Addendum 1

Issue Date: October 9, 2018

Project Name: Regional District of Nanaimo
Coombs-Hilliers Firehall
Water Tanks Replacement

Project Number: 1019-001

PACO Series VL - In-Line Centrifugal Pump, Close Coupled

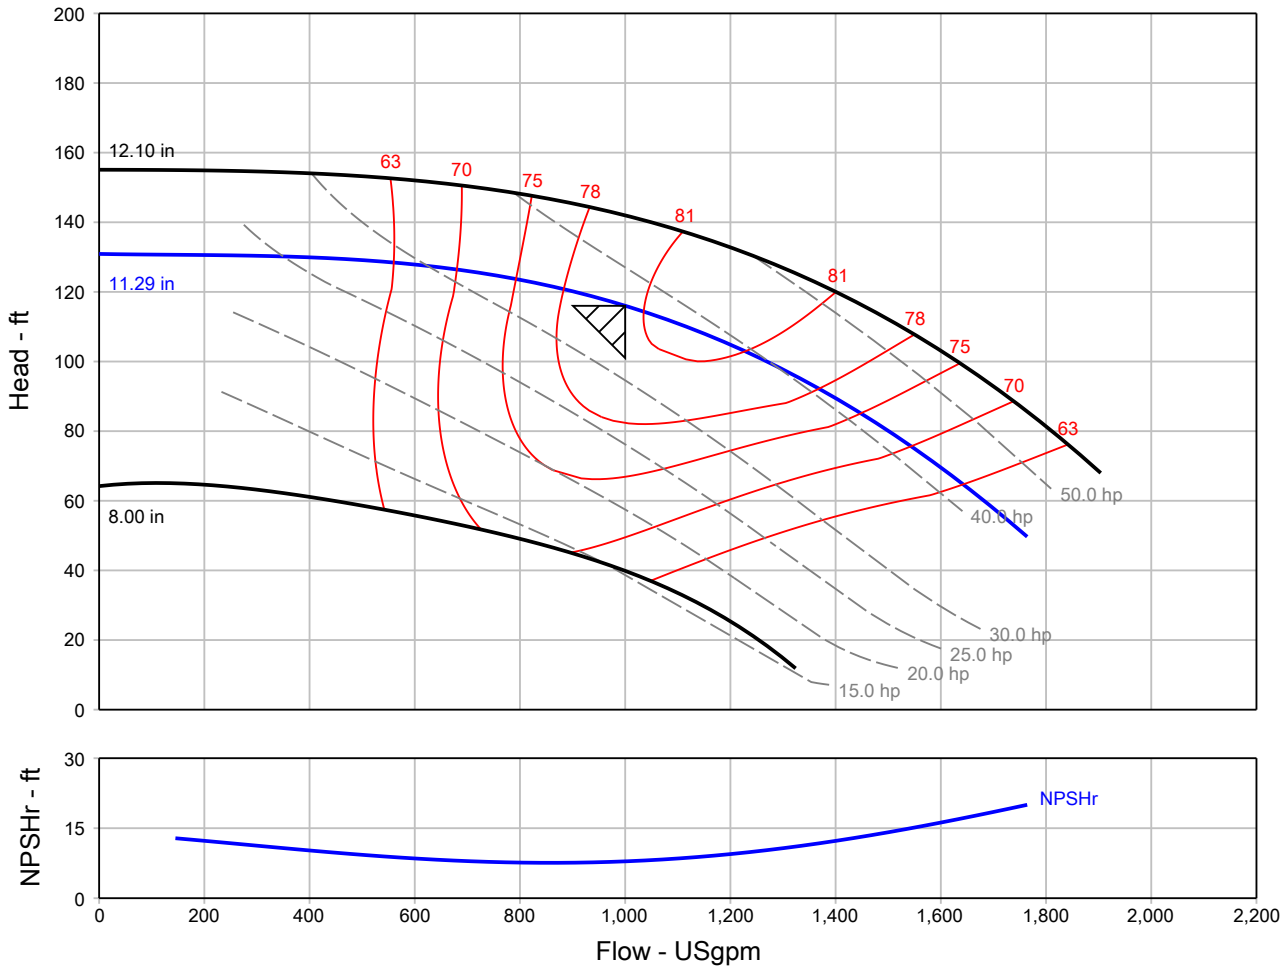
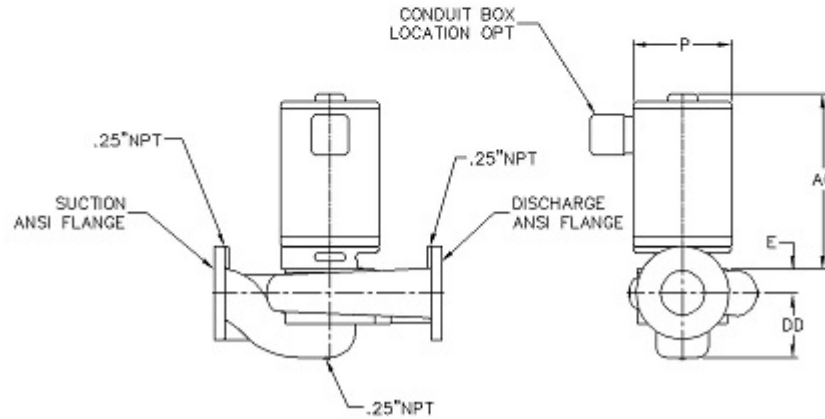
- .2 2.0 PUMP, PIPING AND HYDRANT, .3 Pump Station
Remove "...with integral fuel tank..." from the requirements. The diesel pump will no longer be used, and an electrical driver and pump is now specified. The electrical pump system information is attached to this addendum.
- .3 3.0 WATER STORAGE TANKS, .1 Supply and Install Water Tanks.
Add: "Tanks are to be single-wall polyethylene with a 1.9 Specific Gravity rating"

- Specifications for the electrical pump system to be supplied.

DETAILS

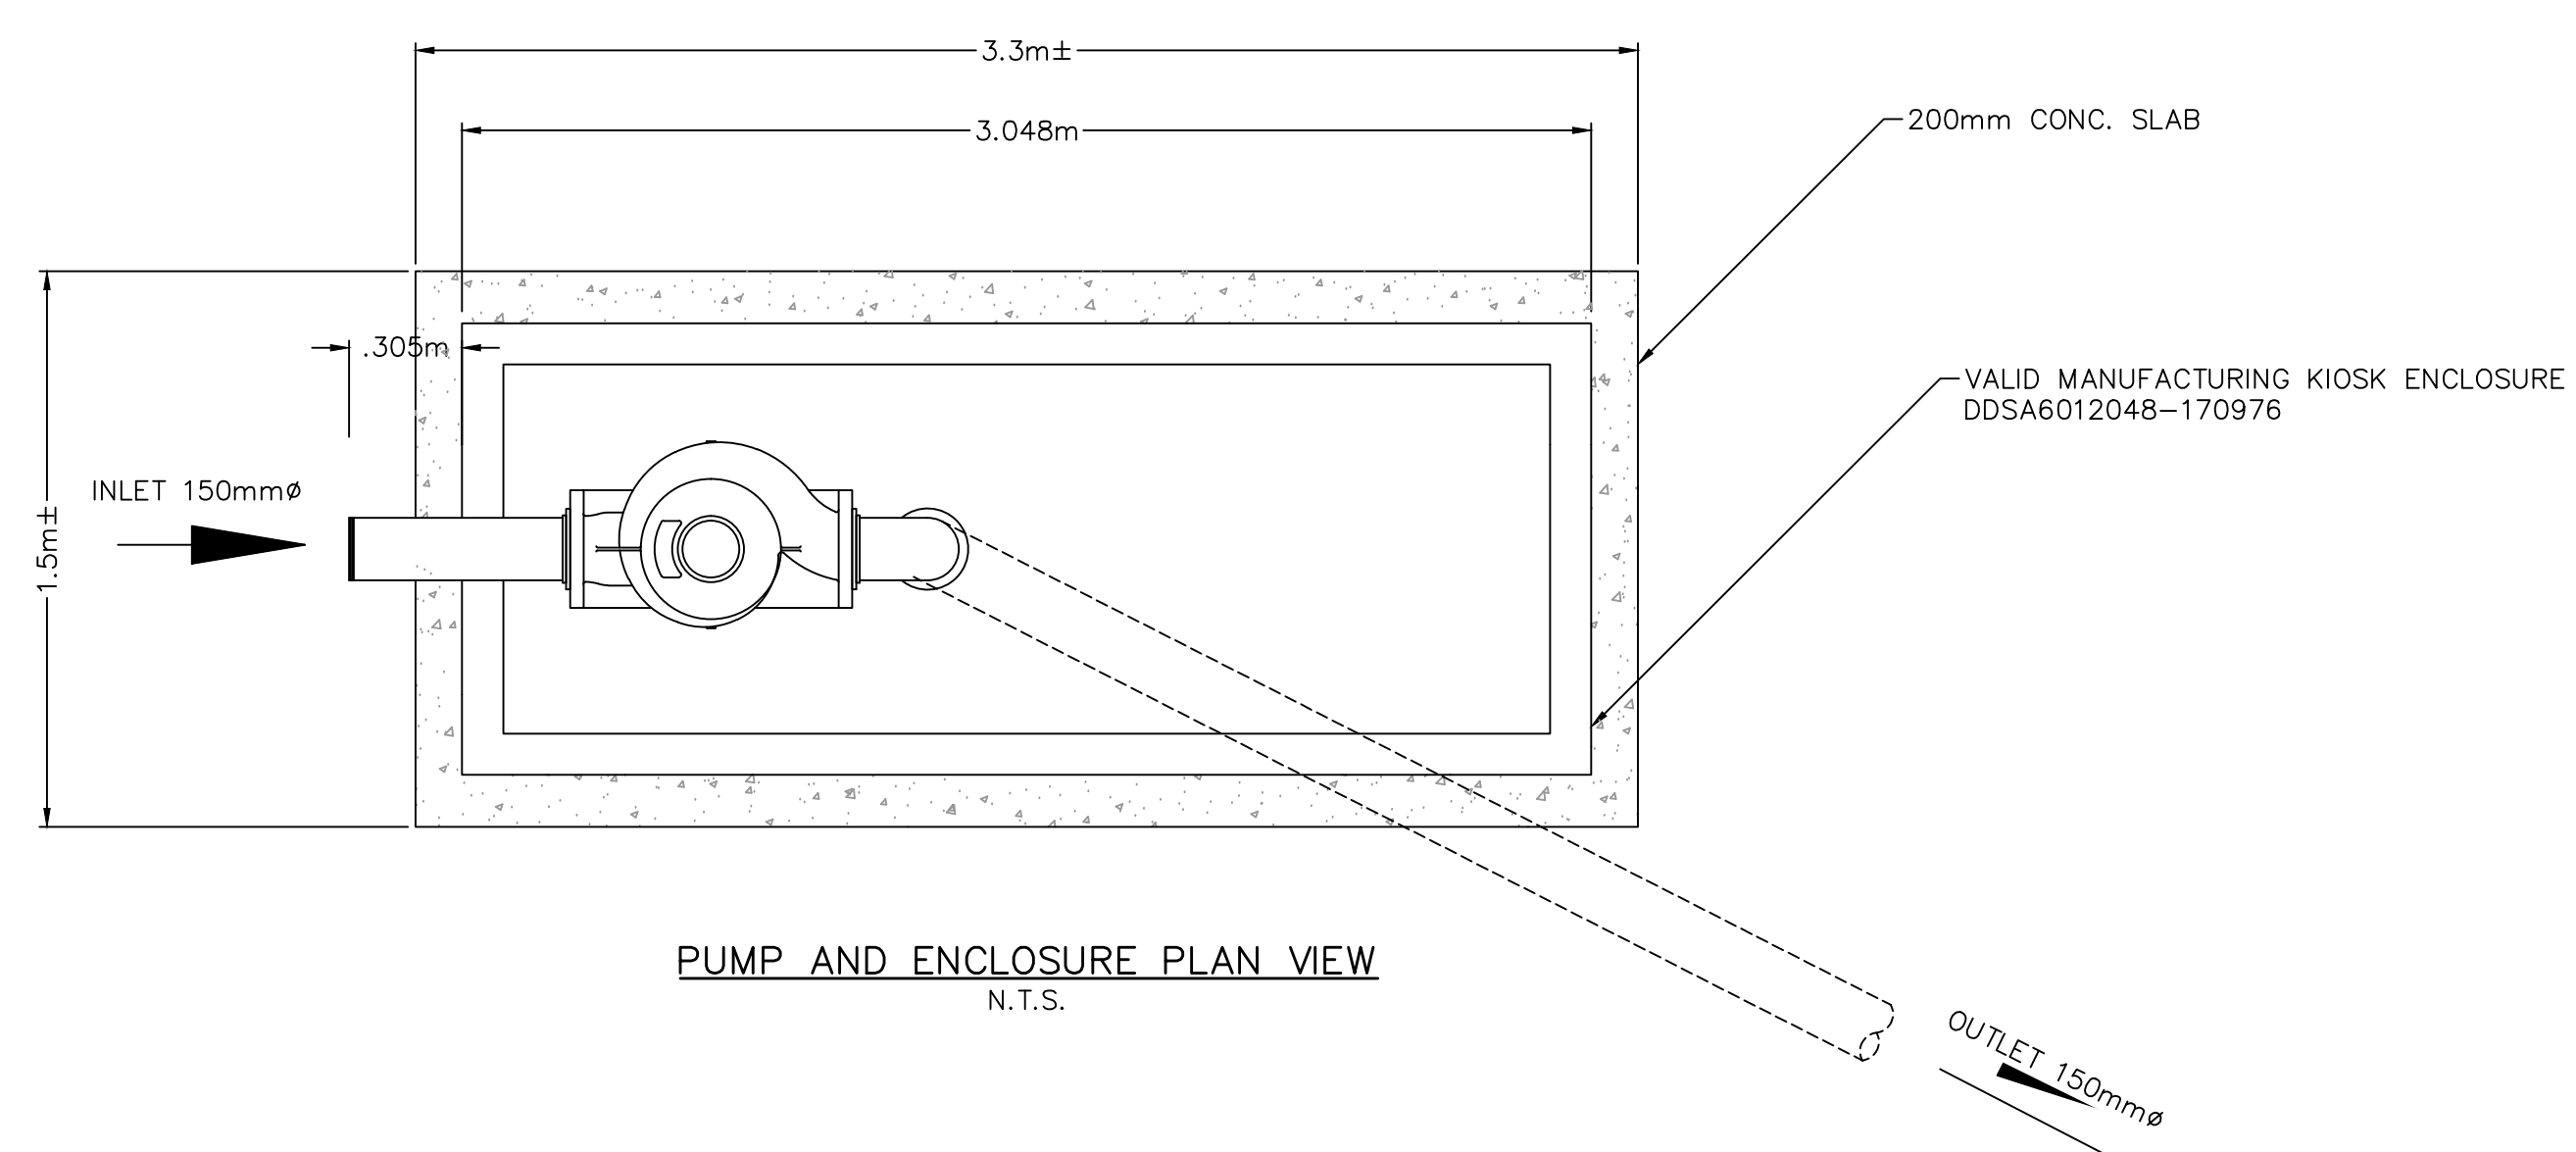
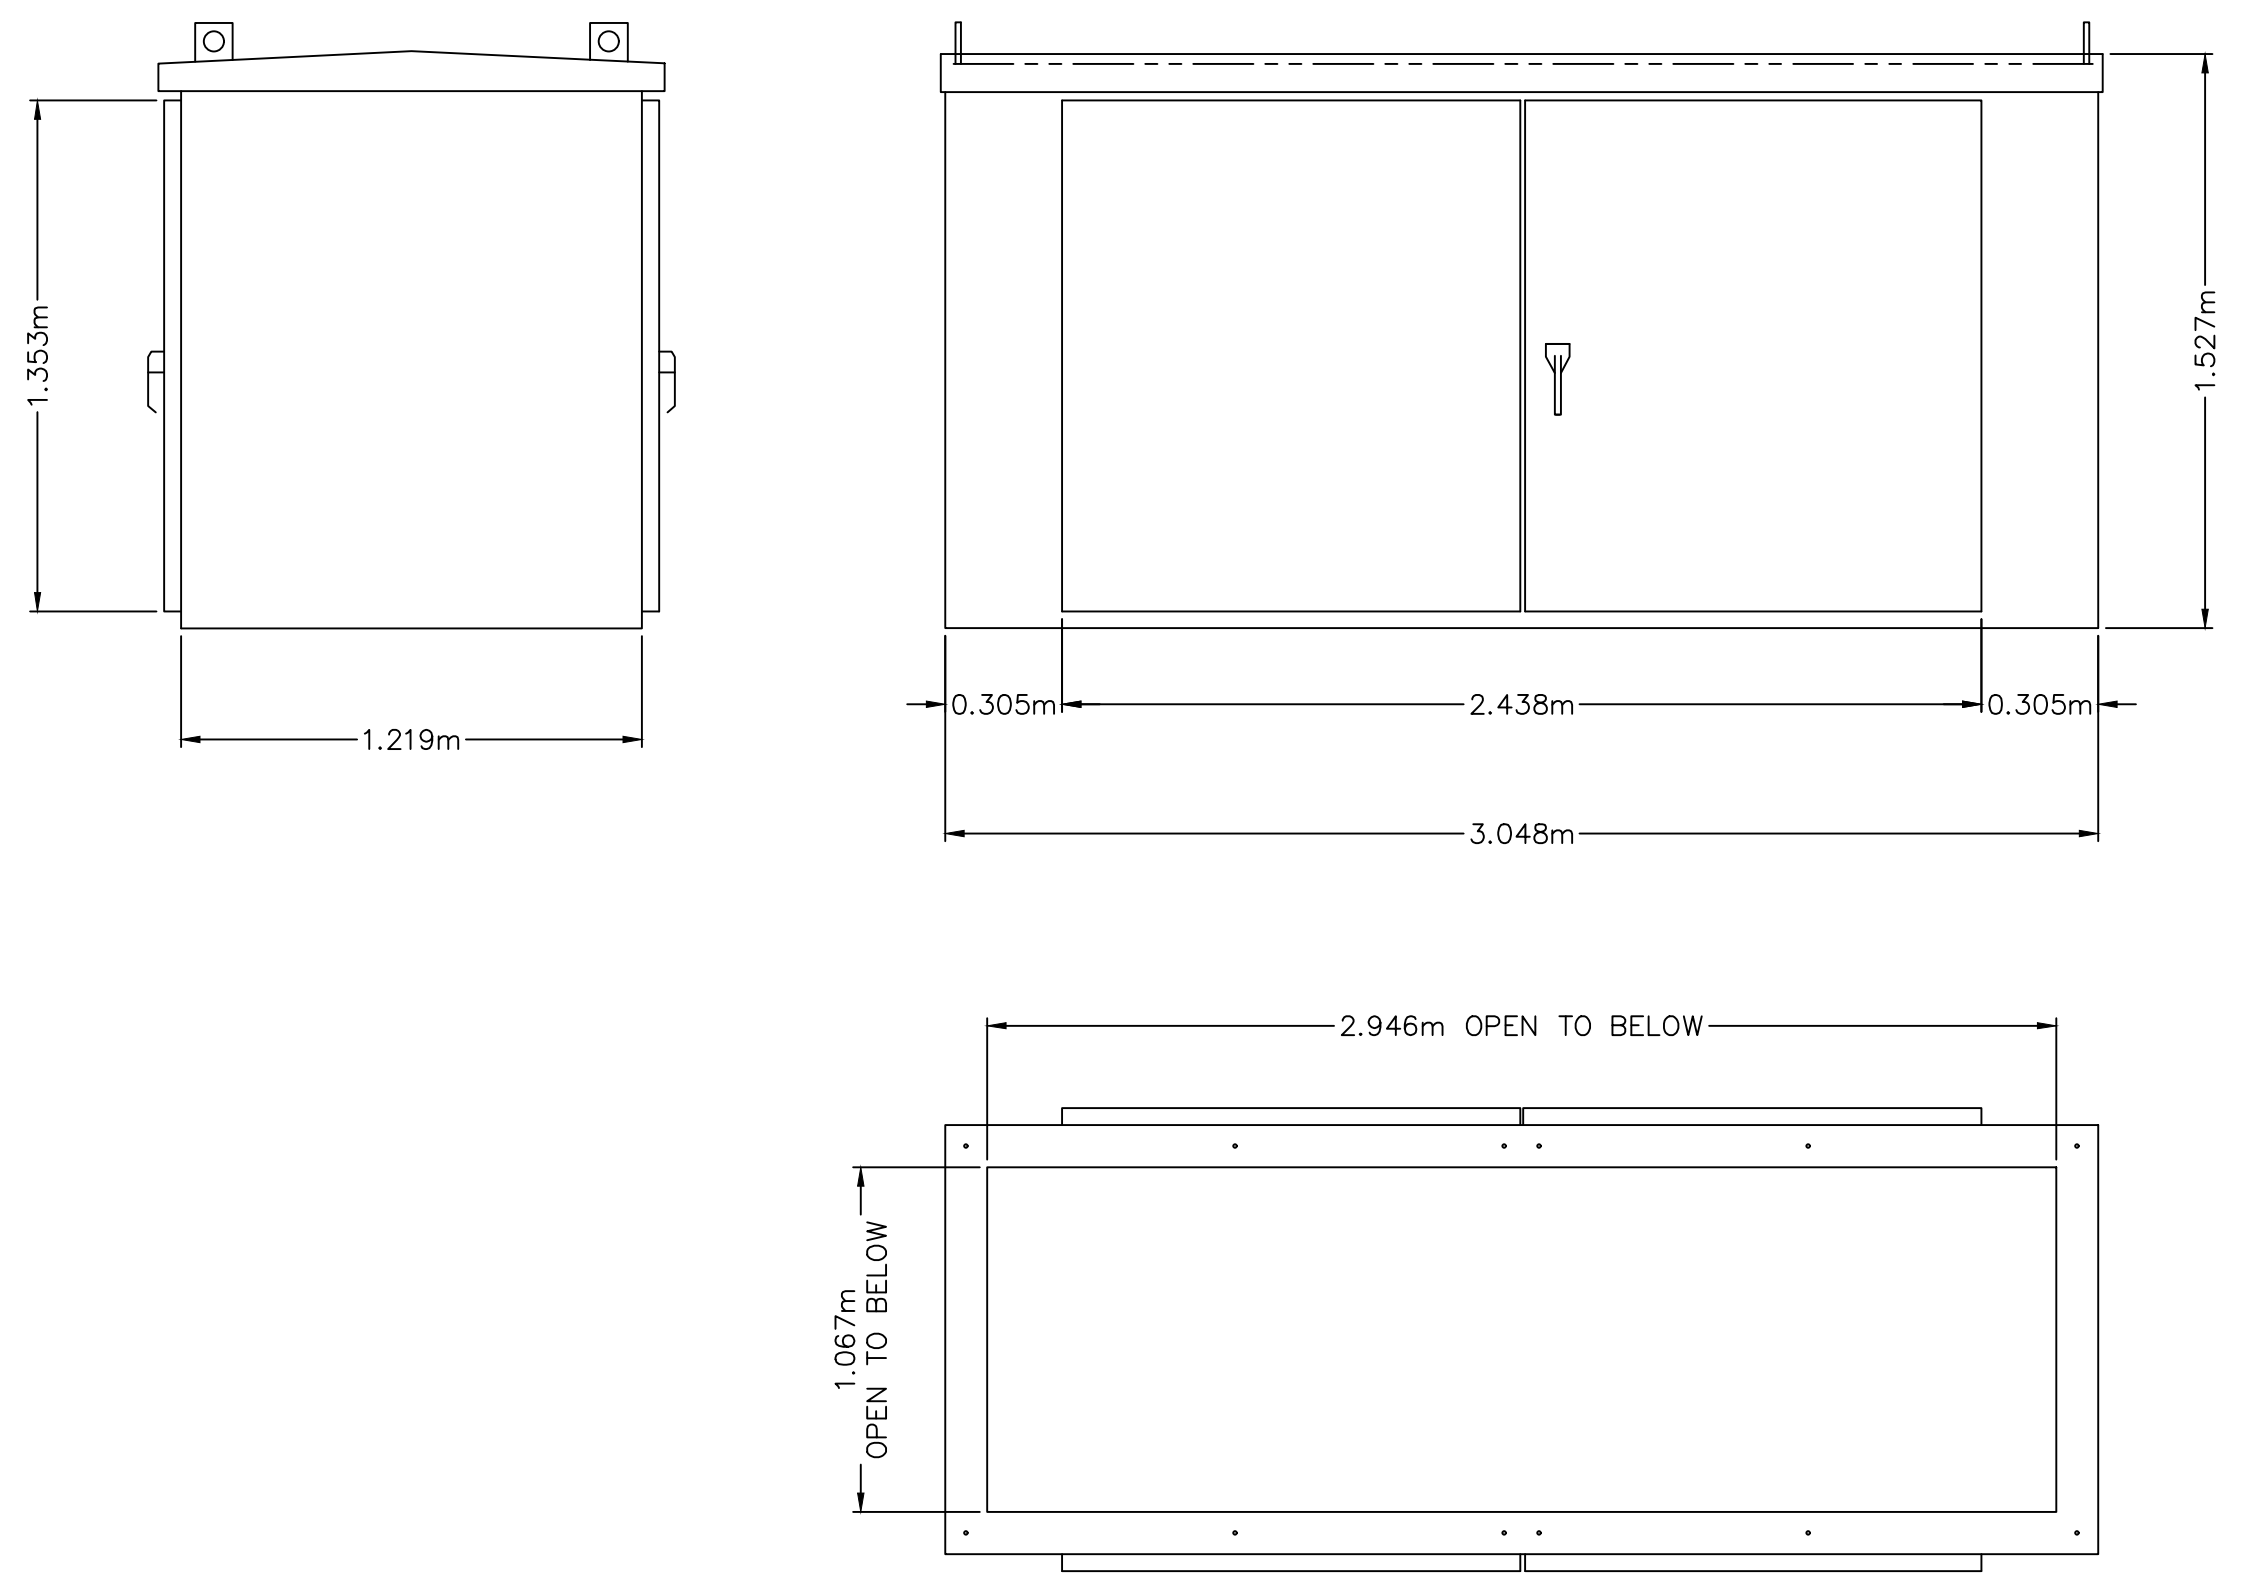
- Q1: What is the hydrant specification and bury requirements
- A1: Terminal City or AVK are acceptable. Hydrant feed line to have minimum 1m of cover.
- Q2: On the Tank Detail Item #8 please confirm if the quantity is 4 or 5?

- A2: Please see attached drawings
- Q3: On the Tank Detail Item #9 please confirm style and Spec?
- A3: Please see attached drawings
- Q4: Is bacteriological testing required for the water piping?

.1 Replace existing drawings with **Rev. F, dated 09OCT18 (attached)**
